6.1.1 T220285 PA - Use and Development of Land for a Medical Centre and alteration of an access in a Transport Zone Schedule 2 at 337 Belgrave-Gembrook Road, Emerald

Responsible GM: Lili Rosic
Author: Jason Gilbert

APPLICATION NO.:	T220285
APPLICANT:	XWB Consulting
LAND:	L14 LP14785, 337 Belgrave-Gembrook Road, Emerald VIC 3782
PROPOSAL:	Use and Development of Land for a Medical Centre and alteration of access to a road in a Transport Zone 2.
PLANNING CONTROLS:	<p>Zone:</p> <ul style="list-style-type: none"> Mixed Use Zone (adjacent to Transport Zone, Schedule 2) <p>Overlays:</p> <ul style="list-style-type: none"> Bushfire Management Overlay Design and Development Overlay – Schedule 4 Vegetation Protection Overlay – Schedule 3
NOTIFICATION & OBJECTIONS:	<p>Notice of the application was given pursuant to Section 52 of the <i>Planning an Environment Act 1987</i>.</p> <p>To date, Council has received twelve (12) objections.</p>
KEY PLANNING CONSIDERATIONS:	<p>Mixed use zone Commercial development Township character Built form outcomes Visual bulk Car parking Traffic</p>
REASON FOR MEETING	The application has received over 4 objections.

Plan:
Basement Level 2 Site/Floor Plan
 Scale: Plan designation: Sheet No.
 1:100 17180504 S044
 Plan size: Date: Revision
 A0/A1 17/07/18 G

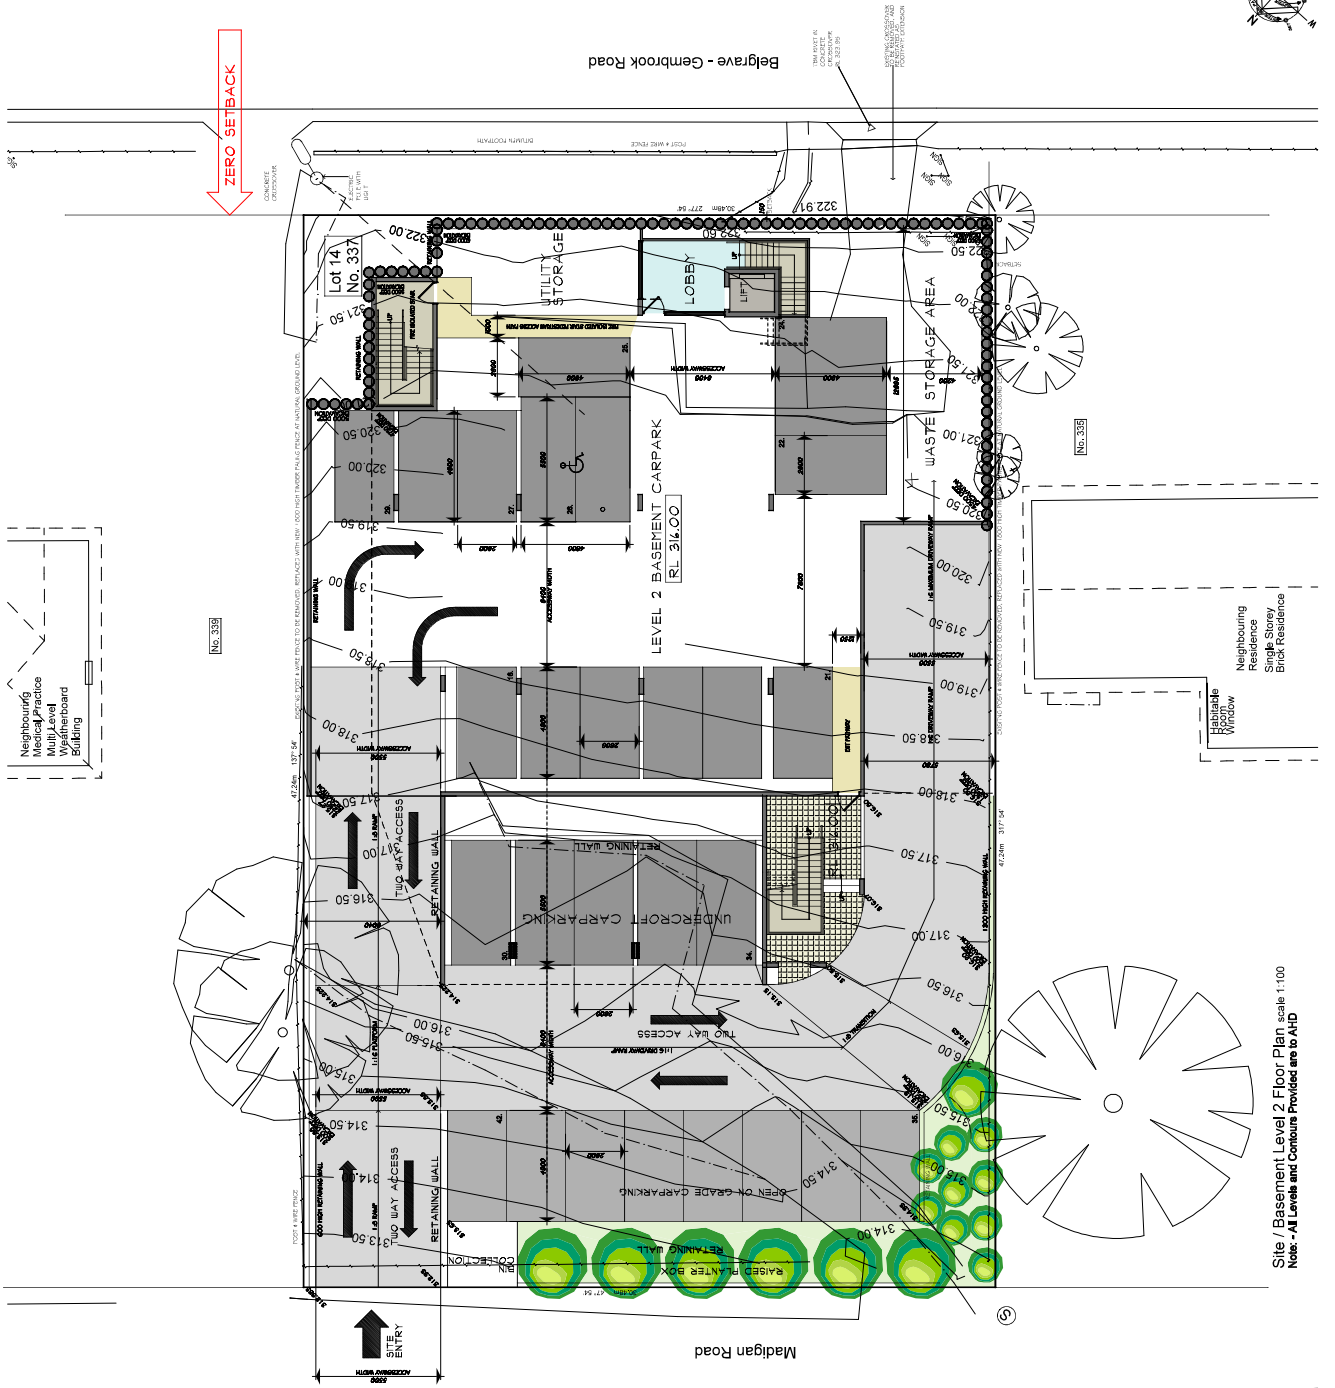
- f. Provision of minimum 500mm overhang for Car Parking Bay 8, Bay 28, Bay 29 ensuring relevant accessway width remains.
 - g. Bay 25 (no clearance to disabled bays) to be removed from level 2 basement carpark, ensuring that minimum 1.2m pedestrian access maintained.

- h. Clarification and update to Bay 24 and a 1m clearance between Bay 24 and Lift, noting this is shown on Swept Path Assessment but not basement floor plan.

West Elevation
 scale 1:100

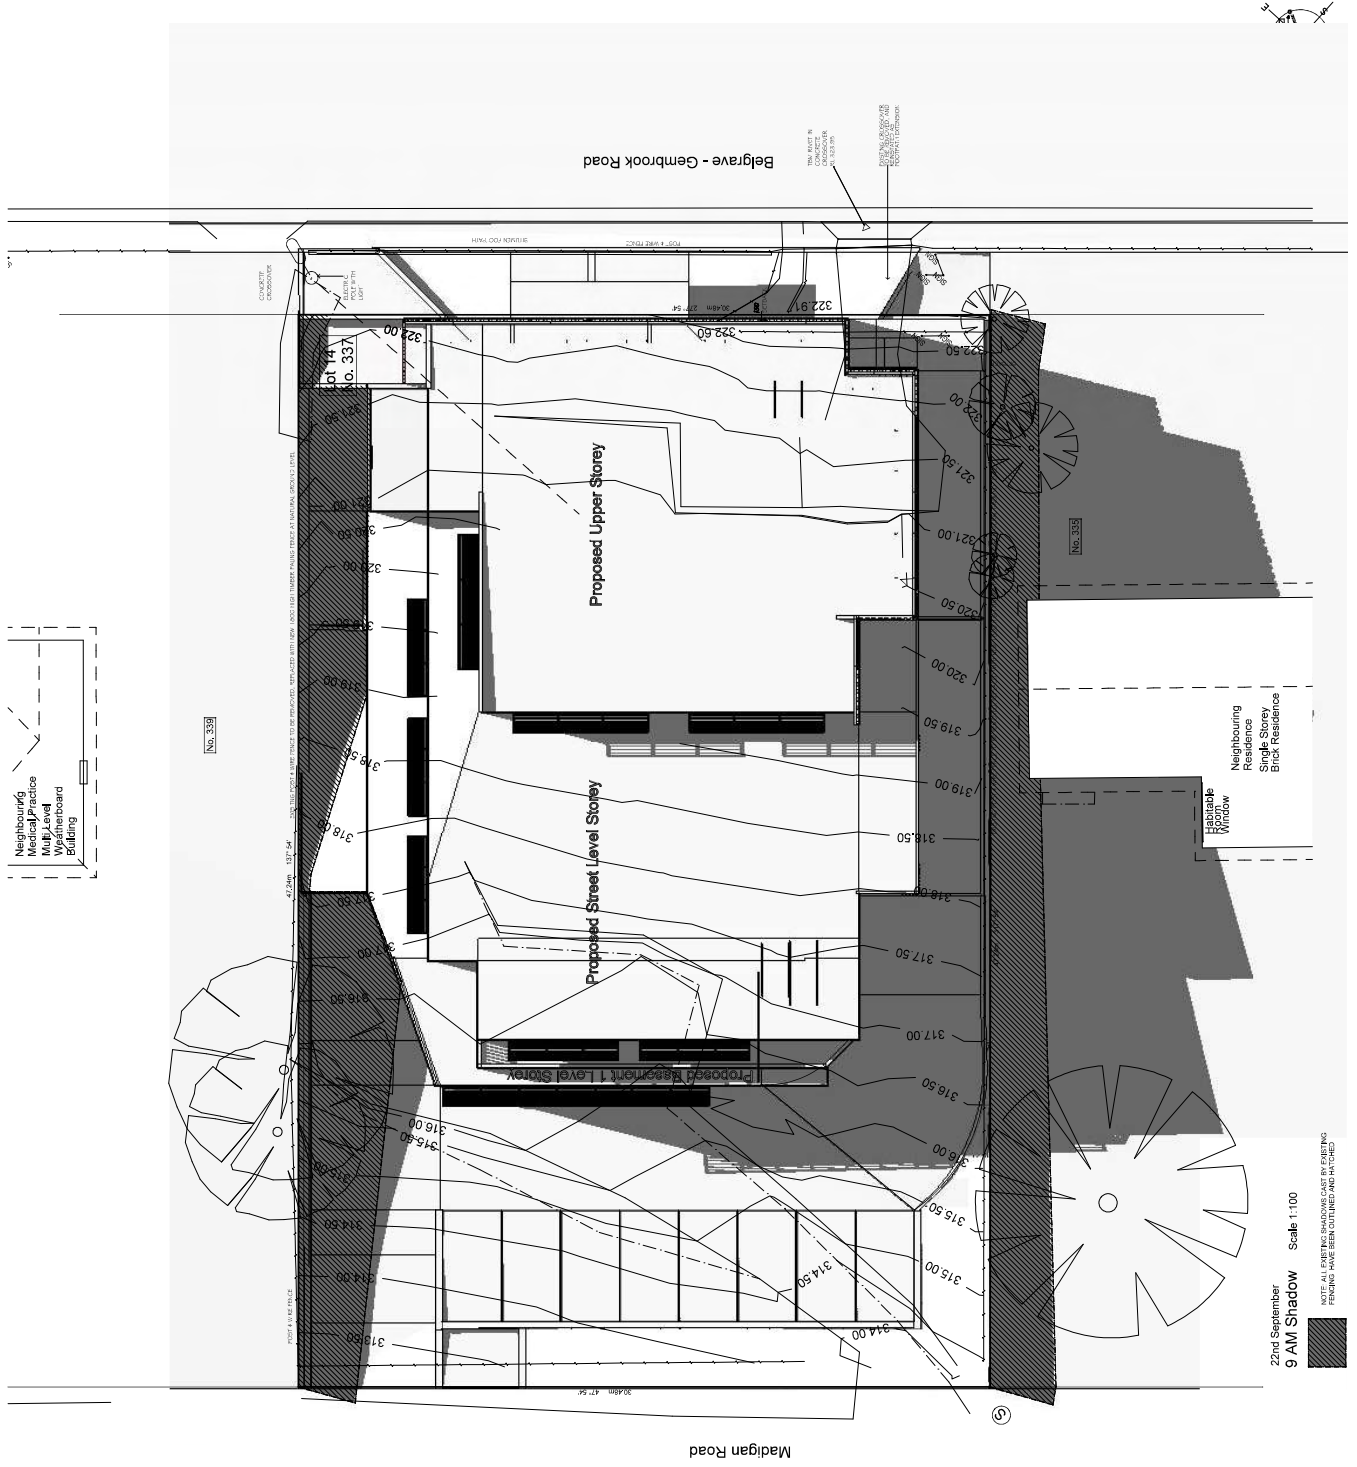
- l. Screening/window treatment to the west to avoid overlooking of adjoining properties.
